# Access Compliance Report

## Public Rights-of-Way

### (Curb Ramps)

Intersection ID: 22536	Main Street: PROVIDENCE_RD	Cross Street: SUMMERTREE_LN	Location: NE
ADA ID: C72F7067091F	Ramp Type: Perp	Initial Pass/Fail: Fail	Overall Compliance: No
		Severity Score: 37.5

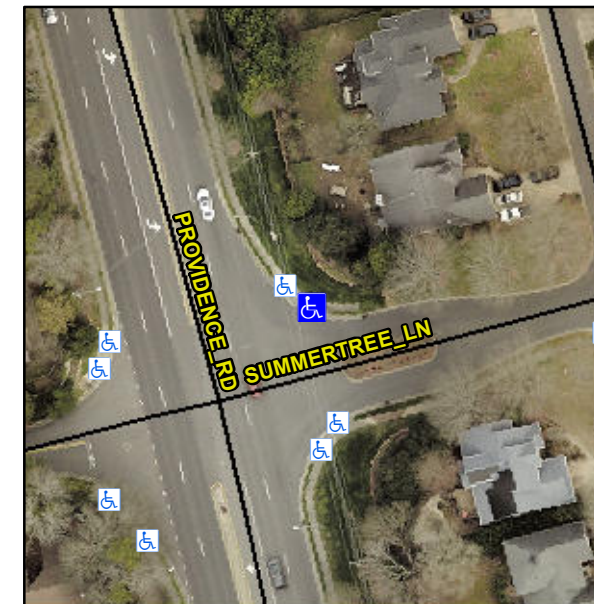
**R304.2.2, R304.5.3**

Compliance	Description	Data	Compliance	Description	Data
N/A	Ramp Length (in)	61.0	No	Ramp Slope (%)	9.7
Yes	Ramp Width (in)	54.0	No	Ramp XSlope (%)	7.2
N/A	Flare Type LT	N/A	N/A	Flare Type RT	N/A
N/A	Flare Slope LT (%)	N/A	N/A	Flare Slope RT (%)	N/A
N/A	Flare Traversable LT?	N/A	N/A	Flare Traversable RT?	N/A
N/A	Landing Length (in)	N/A	N/A	DWS Provided?	N/A
N/A	Landing Width (in)	N/A	N/A	DWS Contrast?	N/A
N/A	Landing Slope (%)	N/A	N/A	DWS Length (in)	N/A
N/A	Landing X Slope (%)	N/A	N/A	DWS Full Width?	N/A
N/A	Landing Curb? (Y/N)	N/A	N/A	DWS Offset (in)	N/A
N/A	Shared Landing?	N/A			
N/A	Gutter Ponding?	N/A	N/A	Gutter Slope (%)	N/A
N/A	Gutter Lip Ht (in)	N/A	N/A	Gutter X Slope (%)	N/A
N/A	Painted X Walk1?	No	N/A	Painted X Walk2?	N/A
	X Walk 1 Direction	To S		X Walk 2 Direction	N/A
N/A	X Walk 1 Width (in)	N/A	N/A	X Walk 2 Width (in)	N/A
	X Walk 1 Slope (%)	6.5		X Walk 2 Slope (%)	N/A
	X Walk 1 X Slope (%)	3.7		X Walk 2 X Slope (%)	N/A

**Remove & Replace Entire Ramp.**
